Subject: Detrex / URS Sediment and DNAPL Delineation Report

Subject: Comments on URS Sediment and DNAPL Delineation Report

On the behalf of Fields Brook Action Group (FBAG), Gradient has reviewed the Sediment and DNAPL Delineation Report prepared by URS for the Detrex property (URS, 2010¹). This letter provides a summary of our review comments.

Detrex Soil Data:
Total VOC
(1992-2009)
Fields Brook Superfund Site - Ashtabula, Ohio

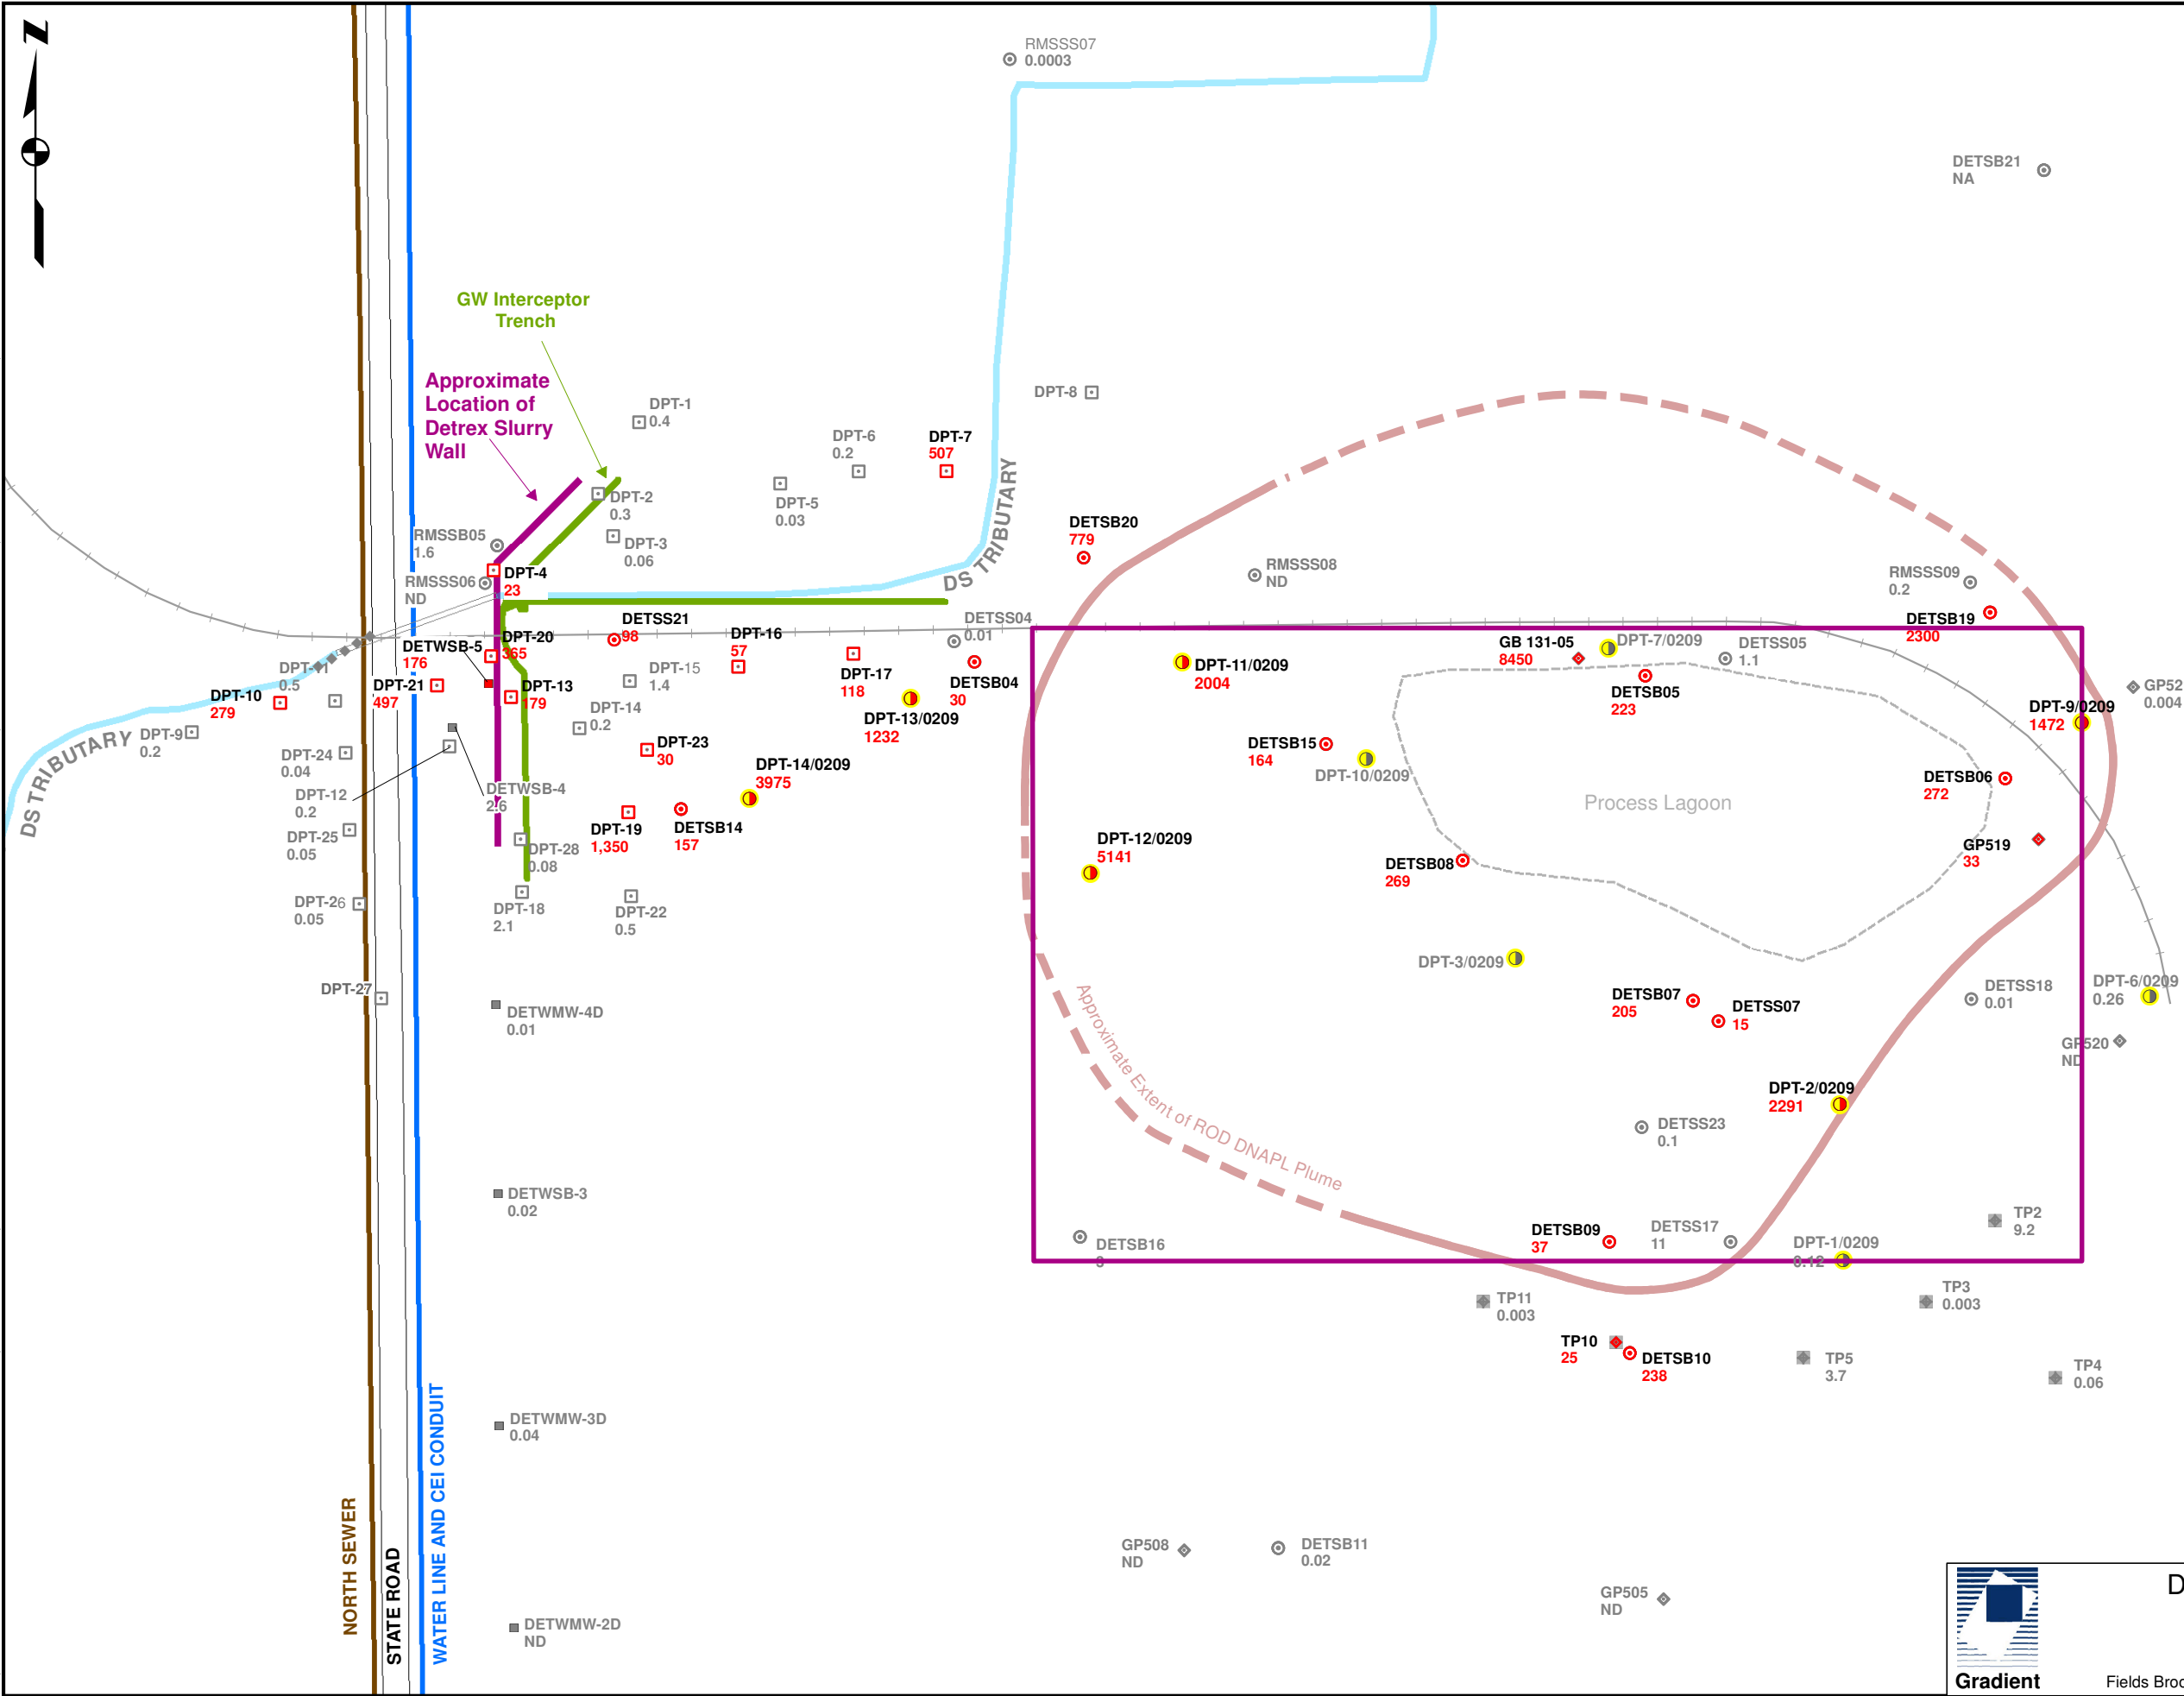
- Soil concentrations measured at the Detrex facility are indicative of mobile DNAPL – material that can migrate through fractured clay. Gradient (2009) had previously calculated a total VOC soil threshold concentration (C_{mobile}), which if exceeded indicates a potential for DNAPL to migrate through fractured clay. A comparison of the soil analytical results reported in this study to the C_{mobile} soil concentration benchmark (total VOCs - 13 mg/kg) confirms the continued presence of mobile DNAPL at the Detrex Facility (Figure 1; Table 3).

- DS Tributary: Prior sampling and the recent URS investigation have encountered soil concentrations indicative of mobile DNAPL (C_{mobile} exceedances) near the uncontained (or unlined) section of the DS Tributary on the Detrex facility (see DPT-7, DETSB-20 and DPT-13; Figure 1). Consequently, DNAPL could easily enter this section of the DS Tributary, migrate *via* the culvert and flow into stream sediments west of State Road, where DNAPL and C_{sat} exceedances have been repeatedly observed since 2005, and again during the URS sediment investigation.
